April 6, 2012

Cogentrix Quail Brush Generation Project – Docket Number 11-AFC-3, Data Request Responses to Set 2

Transmission System Engineering

QUAIL BRUSH A-FRAME DE

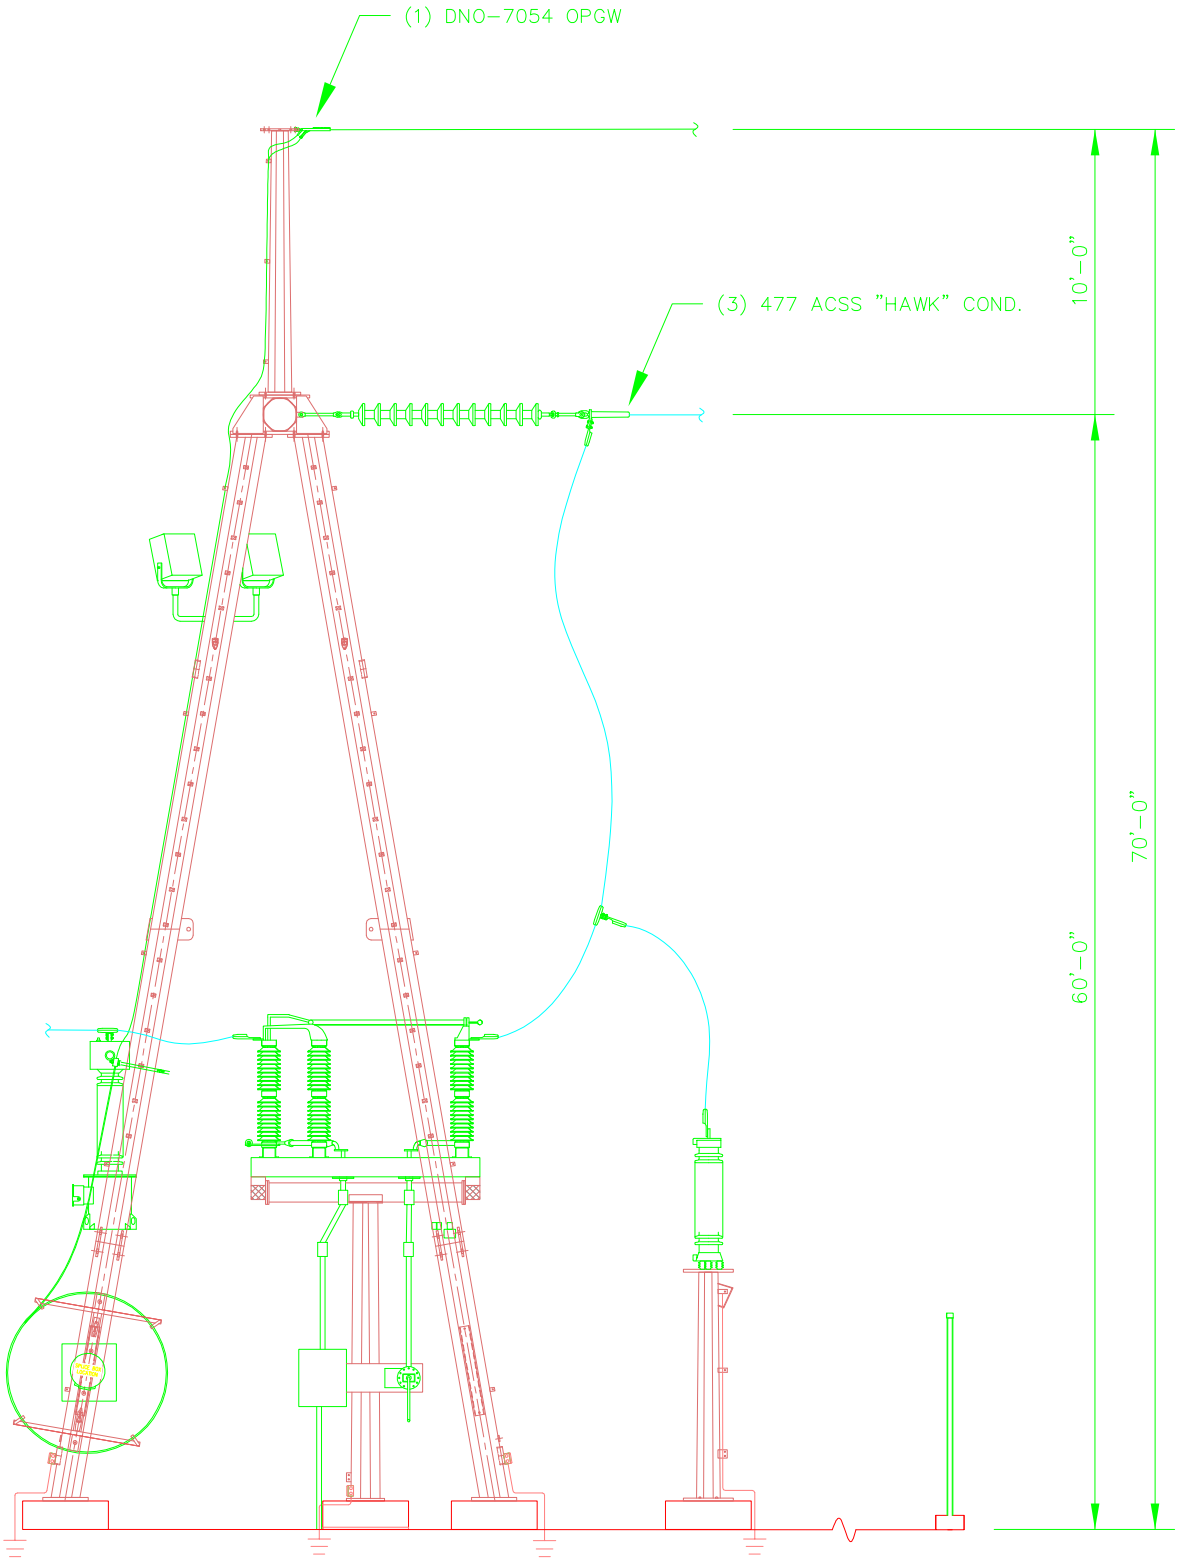
62. Please submit design diagrams of the tangent steel pole and heavy-angle steel pole showing configuration of insulators and conductors with their respective position measurements on the pole including ground clearance from the lowest conductor, height of the pole above and below ground, and the ground conductor, if any, with its size. Also include similar design diagrams of the dead-end poles or structures for the overhead gen tie line at each end.

The dead-end pole at the QBGP switchyard is depicted on Attachment C. The dead-end pole at SDG&E’s Carlton Hills substation is depicted on Attachment L.

QUAIL BRUSH - CARLTON HILLS
138kV TRANSMISSION LINE
PREFERRED ROUTE

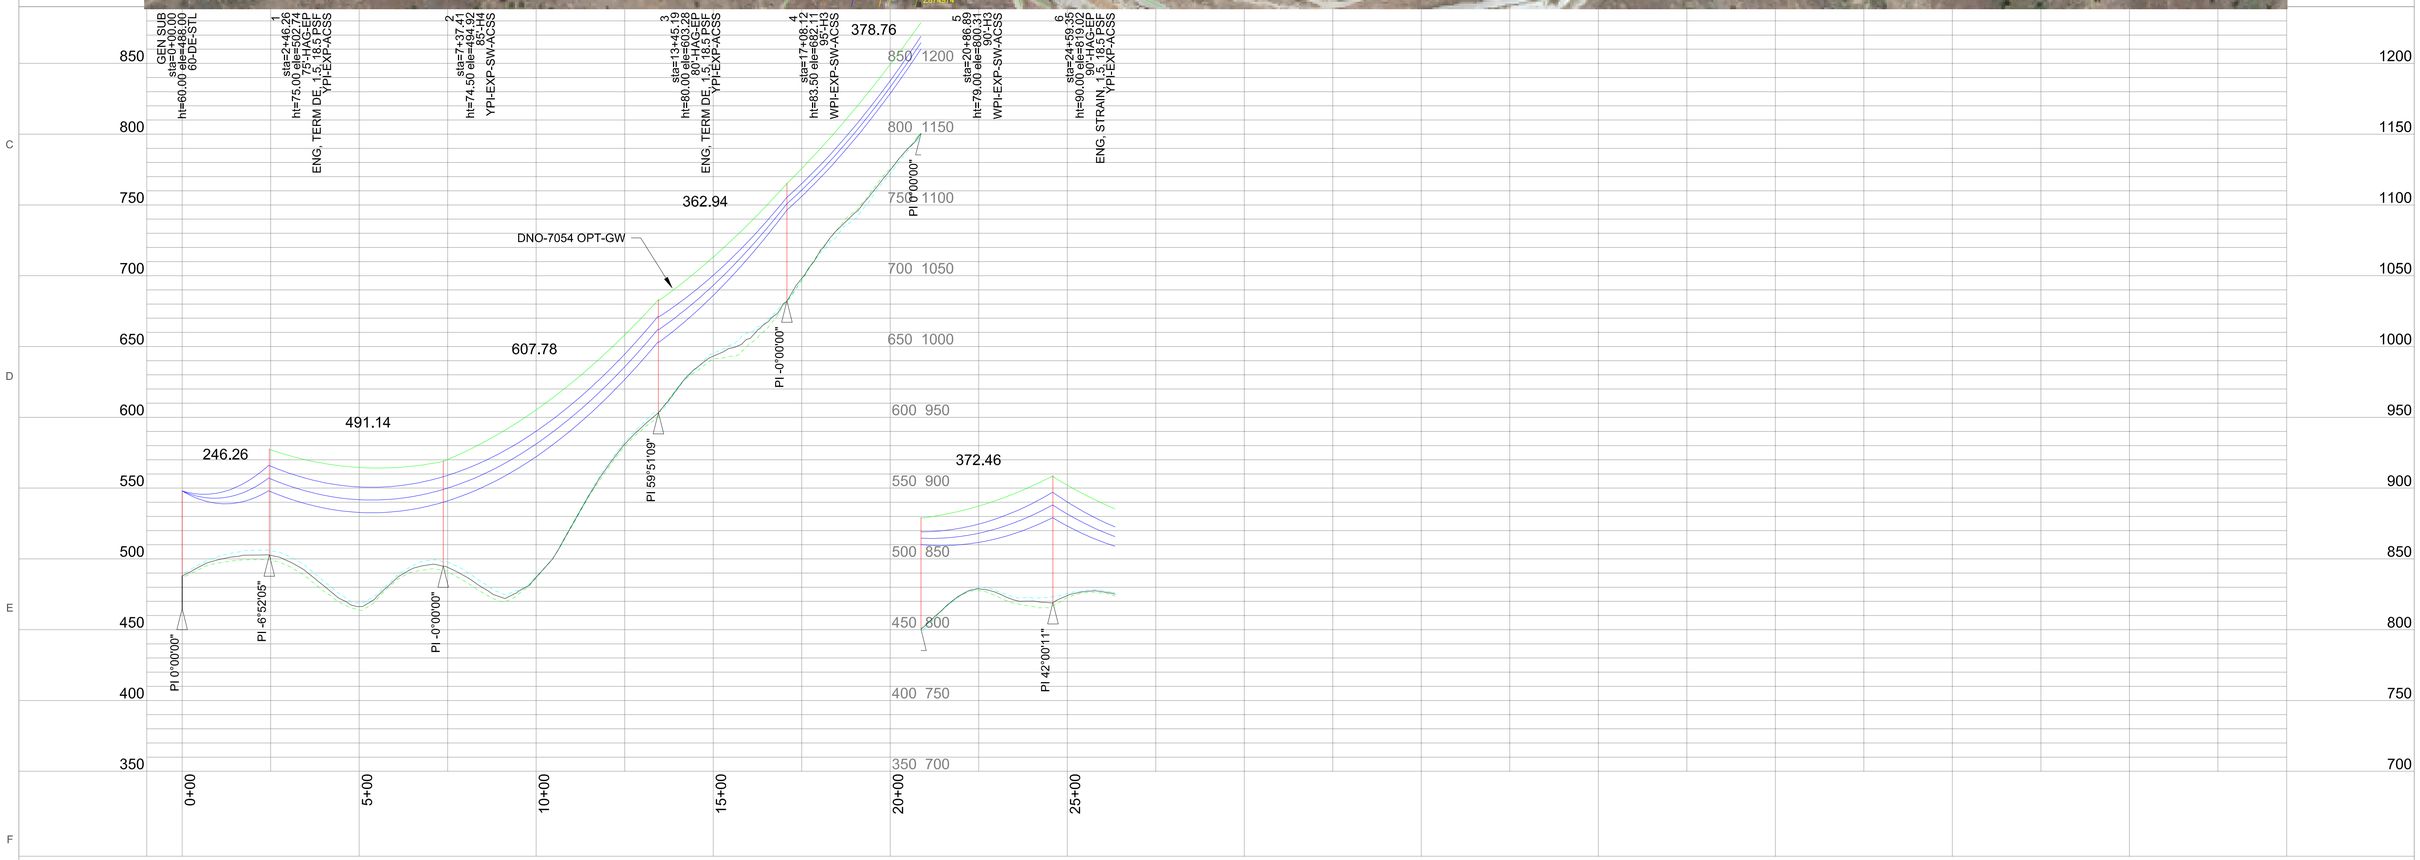
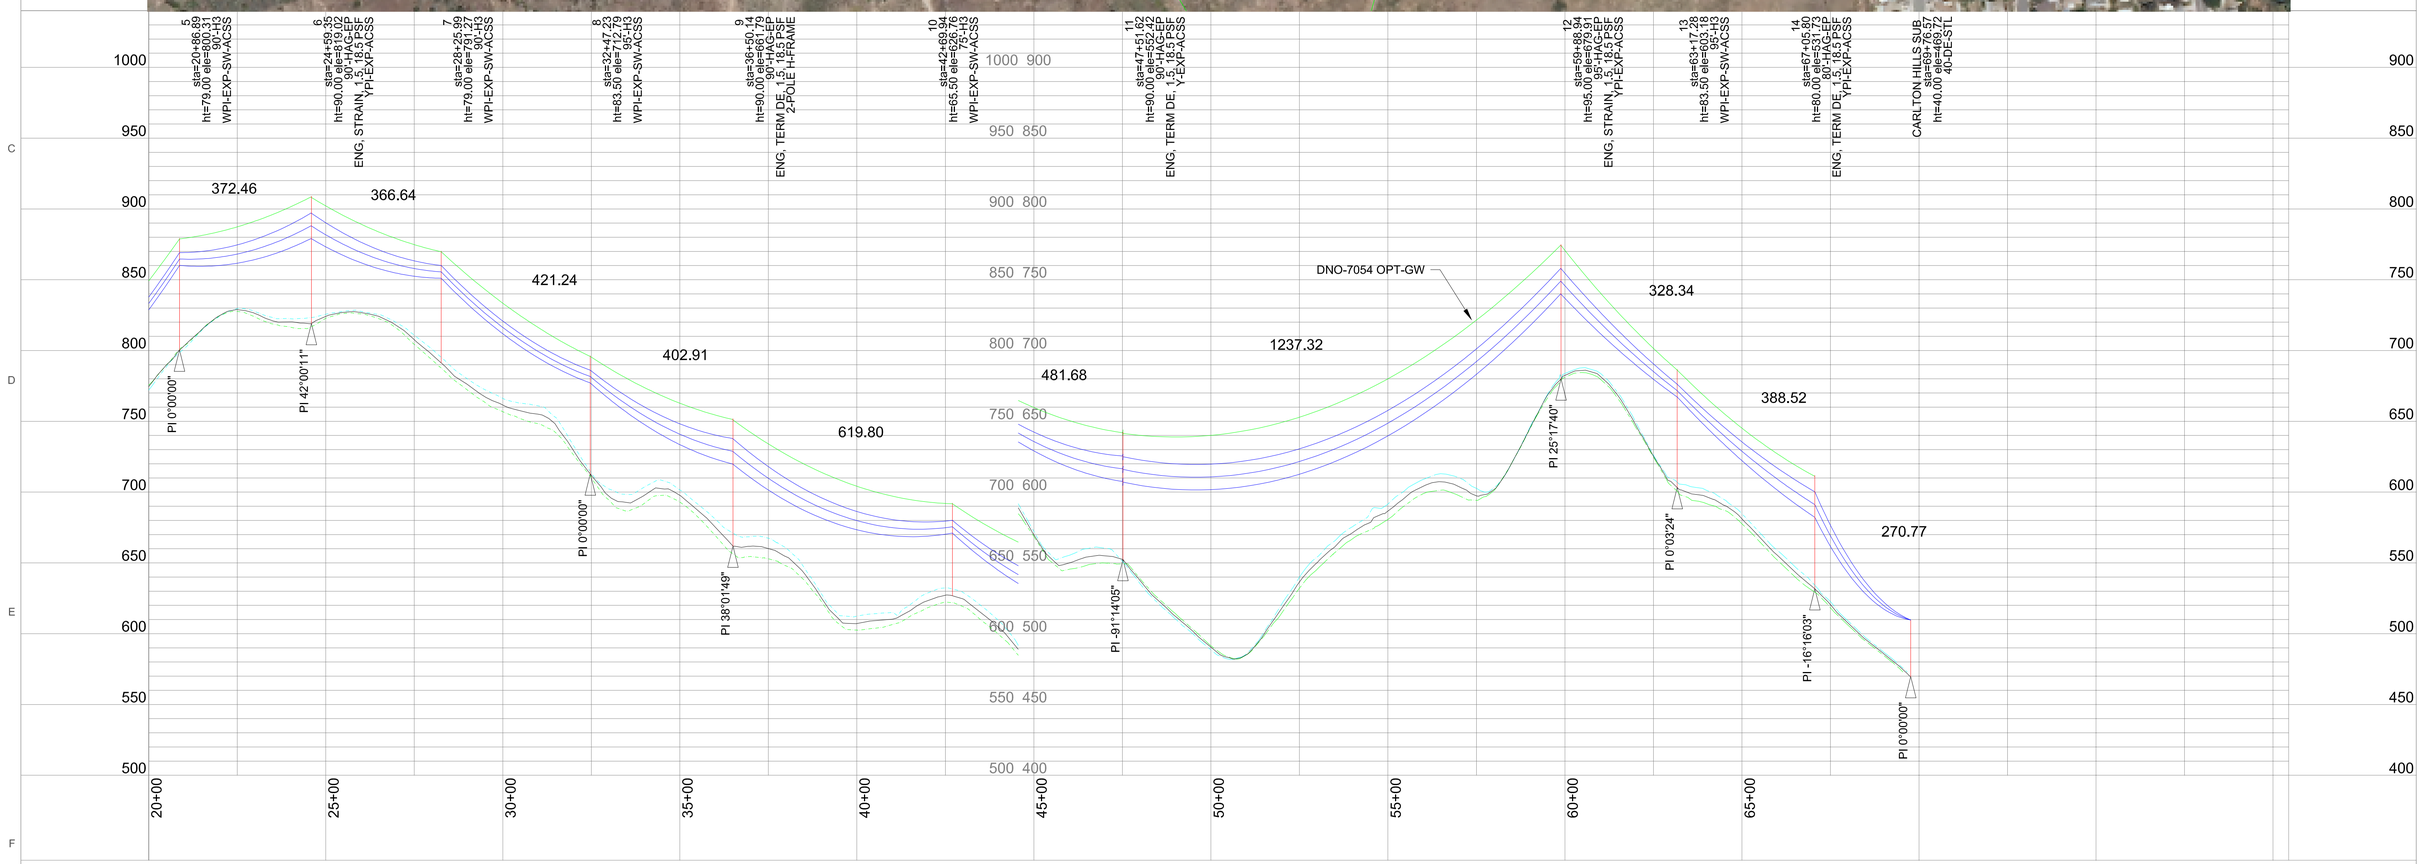
61. Please provide a discussion and drawing of the physical layout showing distinctly (in a larger scale) the preferred route (along any road or land or overhead line) of the proposed 6,850-foot long 138 kV overhead gen tie line including Right of Way (ROW) width(s) between the proposed QBGP 138 kV switchyard and the SDG&E 138 kV Carlton Hills substation. Describe whether the ROW would be through private and/or public lands.

The crossing of the existing SDG&E 138 kV line required in Alternative 2a and Alternative 2b will not be underground. The crossing would be accomplished by passing the gen tie underneath the SDG&E 138 kV transmission lines but above the ground. The required clearances from the gen tie conductors and SDG&E conductors, as well as, between the gen tie conductors and the ground shall be maintained. Plan and profile drawings for the Preferred, Alternate 2a, and Alternative 2b gen tie routes are included as Attachments D, E, and F, respectively.
